Access Compliance Report

Public Rights-of-Way

(Curb Ramps)

Intersection ID: 42456	Main Street: SUNNINGHILL_PARK_RD	Cross Street: KINGSLEY_VIEW_DR	Location: NW
ADA ID: EC8D455DD6E0	Ramp Type: PerpDiag	Initial Pass/Fail: Fail	Overall Compliance: No
Severity Score: 58.75			
Codes/Mitigation Info/Possible Solution		Field Measurements/Component Compliance

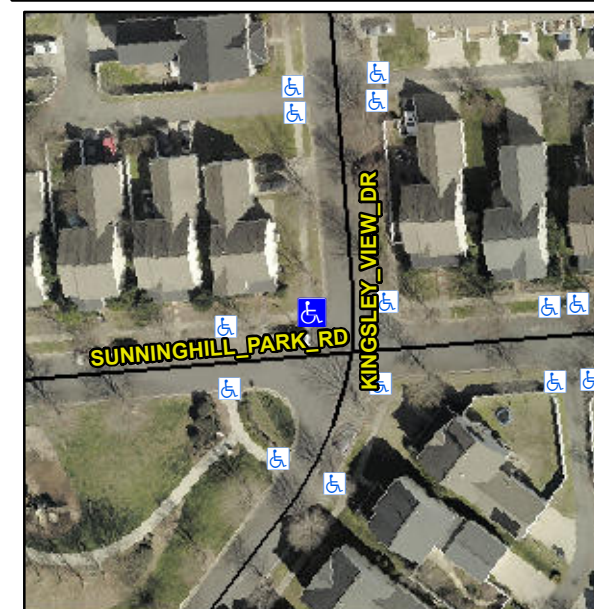
Not Found, R304.5.1, R304.2.2, R304.5.3

Compliance	Description	Data	Compliance	Description	Data
N/A	Ramp Length (in)	133.0	No	Ramp Slope (%)	12.0
No	Ramp Width (in)	46.0	No	Ramp XSlope (%)	10.4
N/A	Flare Type LT	N/A	N/A	Flare Type RT	N/A
N/A	Flare Slope LT (%)	N/A	N/A	Flare Slope RT (%)	N/A
N/A	Flare Traversable LT?	N/A	N/A	Flare Traversable RT?	N/A
N/A	Landing Length (in)	N/A	N/A	DWS Provided?	N/A
N/A	Landing Width (in)	N/A	N/A	DWS Contrast?	N/A
N/A	Landing Slope (%)	N/A	N/A	DWS Length (in)	N/A
N/A	Landing X Slope (%)	N/A	N/A	DWS Full Width?	N/A
N/A	Landing Curb? (Y/N)	N/A	N/A	DWS Offset (in)	N/A
N/A	Shared Landing?	N/A			
N/A	Gutter Ponding?	N/A	N/A	Gutter Slope (%)	N/A
N/A	Gutter Lip Ht (in)	N/A	N/A	Gutter X Slope (%)	N/A
N/A	Painted X Walk1?	No	N/A	Painted X Walk2?	No
	X Walk 1 Direction	To S		X Walk 2 Direction	To E
N/A	X Walk 1 Width (in)	N/A	N/A	X Walk 2 Width (in)	N/A
	X Walk 1 Slope (%)	3.1		X Walk 2 Slope (%)	3.9
	X Walk 1 X Slope (%)	5.5		X Walk 2 X Slope (%)	5.8

Remove & Replace Curb Ramp With Two New Directional Ramps or Equivalent.
